Subject: Oyster Creek Generating Station
Docket No. 50-219
Facility Operating License No. DPR-16
Technical Specification Change Request No. 281
Response to Request for Additional Information

Technical Specification Change Request No. 281

Response to Request for Additional Information

Figure 2

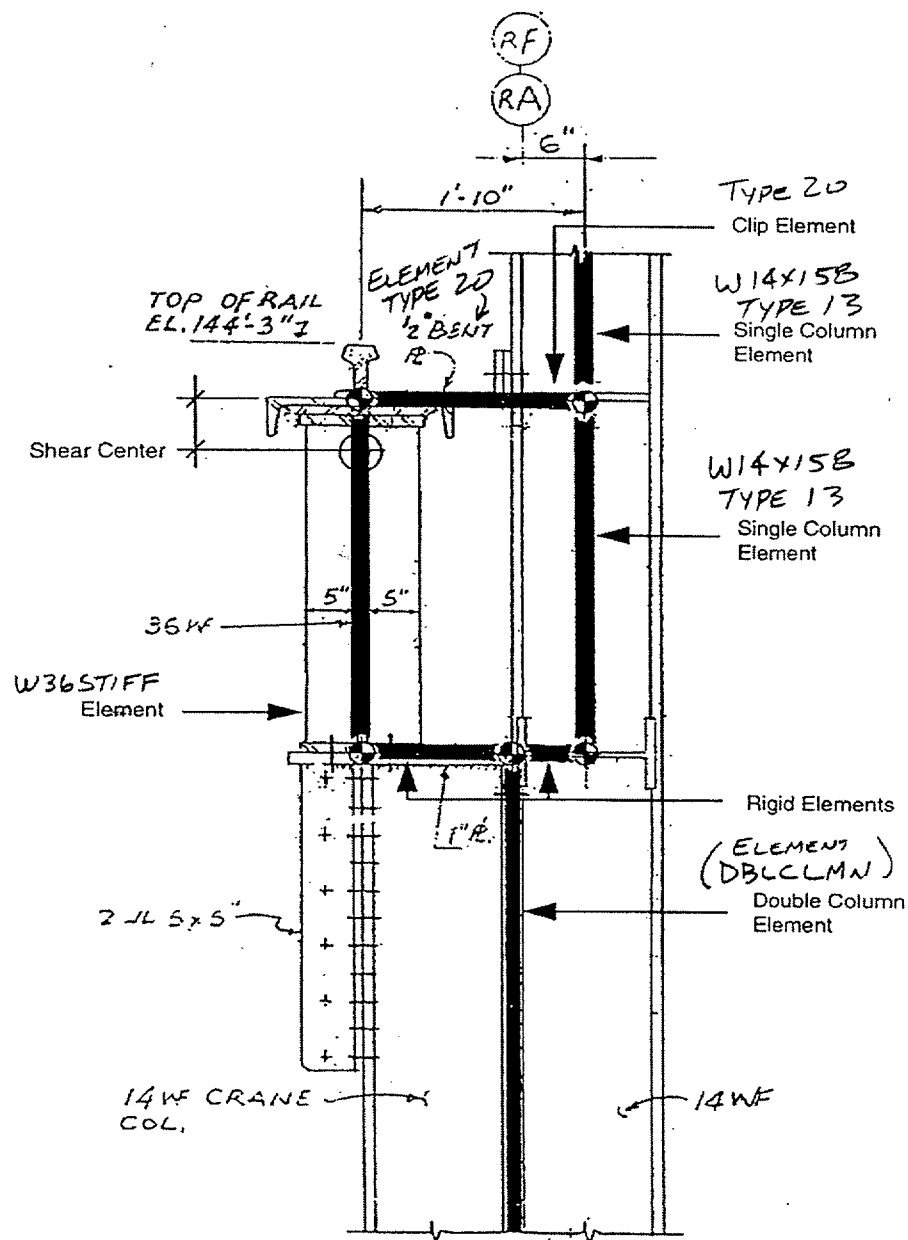
- Crane runway girder to column (bottom): four bolt stiffened beam seat connection (see Figure 2) with 1-inch A325 bolts. Maximum bolt shear is 10.7 kip versus AISC normal allowable of 23.6 kip, maximum bolt tension is 23.8 kip versus AISC normal allowable of 30.8 kip using AISC Table J3.3 for allowable tension with shear.

- Crane runway girder to column (top): a tie plate connects the top of the crane runway girder to the upper column section (element type 20 in Figure 2). The tie plate stress exceeded the acceptance criteria. A modification to the tie plate was designed so it would meet the criteria (Figures 7 and 8). After the design was completed, the model was revised to reflect the modified tie plate. The modification had no effect on the modal frequencies of the model or the resultant forces in the tie plate.
